**U.S. Army Corps  
of Engineers**  
Engineering and Support  
Center, Huntsville

## **Replica SAC**

**Building 5037  
Fort Bliss, TX**

**POTR – Phase 1  
Project No 74516**

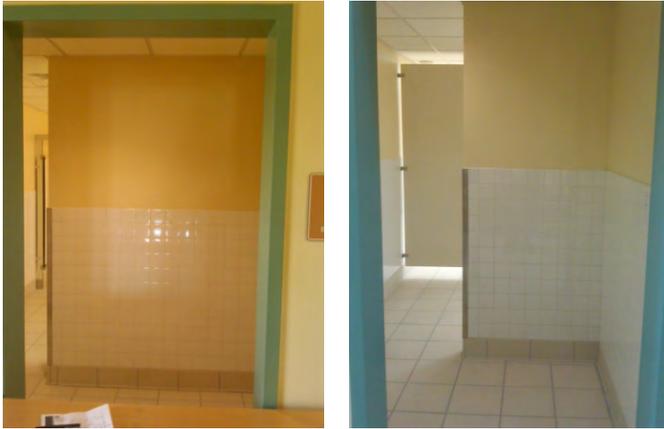
- Video cameras must now be able to monitor the entrances to the staff restrooms. This needs to be updated in the standards and criteria ASAP.
- There are line of sight issues with all of the children restrooms. The 2 remote restrooms are much better (picture below left). The primary restrooms had to have screens added (picture below right, showing the screen). This needs to be resolved in the standard designs.
